UNITED STATES PATENT AND TRADEMARK OFFICE

APPLICATION NO.	FILING DATE	FIRST NAMED INVENTOR	ATTORNEY DOCKET NO.	CONFIRMATION NO.
10/788,740	03/01/2004	Daxiong Ji	967AAF	6104
7590	07/28/2005			
Kevin Redmond 6960 SW Gator Trail Palm City, FL 34990			EXAMINER GLENN, KIMBERLY E	
			ART UNIT 2817	PAPER NUMBER

Office Action Summary

DETAILED ACTION

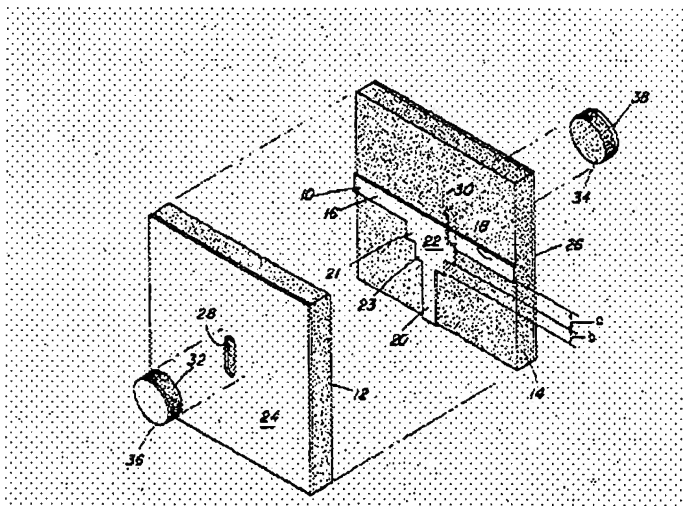
The drawings are objected to because in figure 1-- Prior Art-- is spelled incorrectly. Corrected drawing sheets in compliance with 37 CFR 1.121(d) are required in reply to the Office action to avoid abandonment of the application. Any amended replacement drawing sheet should include all of the figures appearing on the immediate prior version of the sheet, even if only one figure is being amended. The figure or figure number of an amended drawing should not be labeled as "amended." If a drawing figure is to be canceled, the appropriate figure must be removed from the replacement sheet, and where necessary, the remaining figures must be renumbered and appropriate changes made to the brief description of the several views of the drawings for consistency. Additional replacement sheets may be necessary to show the renumbering of the remaining figures. Each drawing sheet submitted after the filing date of an application must be labeled in the top margin as either "Replacement Sheet" or "New Sheet" pursuant to 37 CFR 1.121(d). If the changes are not accepted by the examiner, the applicant will be notified and informed of any required corrective action in the next Office action. The objection to the drawings will not be held in abeyance.

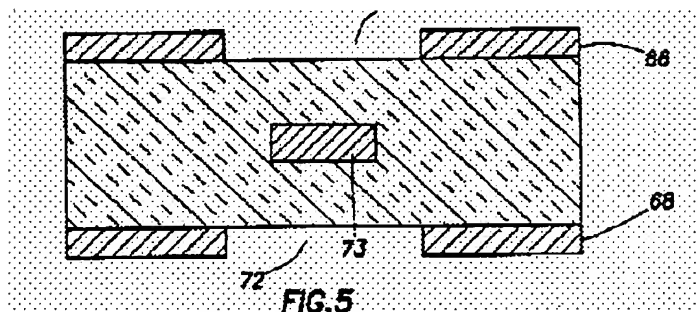
Wright disclose in figure 1, a trace disposed in a dielectric layer and flanked on the top and the bottom by conductive layers 66, and 68. Each of the conductive layers has an array of windows. The windows are located symmetrically with respect to traces 73. The characteristic impedance of the line depends on the dimension of the slots (windows) and the spacing between the slots. ^{col} 16, ^{lines} column 34-43 and column 5 lines 29-34)

One of ordinary skill in the art would have found to obvious to replace to general conductive materials of Plunk et al with the conductive layers having an array of windows as taught by Wright et al. The motivation for this modification would have been to control the impedance of the conductors.

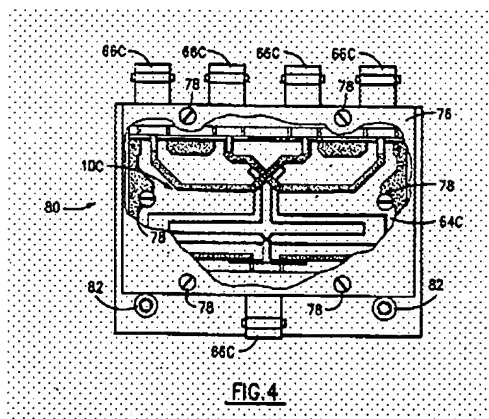
Gustafson disclose in figure 4, a splitter (divider) disposed in a housing 76 (case). The splitter circuit board is mounted in the housing using mounting hardware 78.

One of ordinary skill in art at the time of the invention would have found to obvious to place the divider of Plunk et al in the housing as taught by Gustafson. When the dielectric layers of Plunk et al are placed in the housing by the mounted hardware. The conductive material will be connected to the case. The motivation for this modification would have been the provided the advantageous benefit of circuit protection from environmental factors (dust, water etc).
